NS Power IRP

Comments received from Participants in response to Modeling Results

July 2020

Figure 1: Wind Resources Capacity Factor Histogram

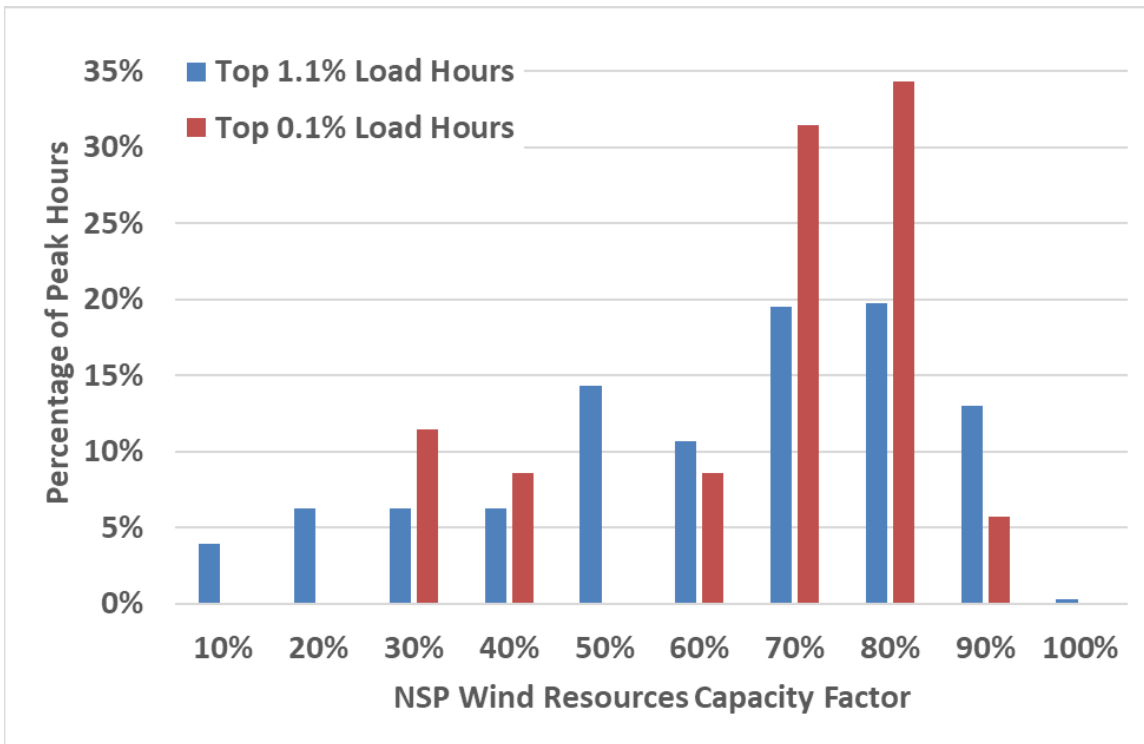
The generation data supplied by NS Power are significantly different from those presented in Figure 13 of the E3 Capacity Value Study. As shown in Table 1 and Figure 1, the generation data supplied by NS Power indicates that the average capacity factor during those hours was over 50% in the years for which data was provided, and at or below the 19% ELCC Factor assumed by NS Power for the IRP only about 10% of the time.

The IRP relies on the ELCC for two related purposes, valuing the capacity provided by existing wind generation and valuing the capacity provided by incremental wind resources. It is important to get both correct, since the existing wind generation counts towards meeting the planning reserve margin.
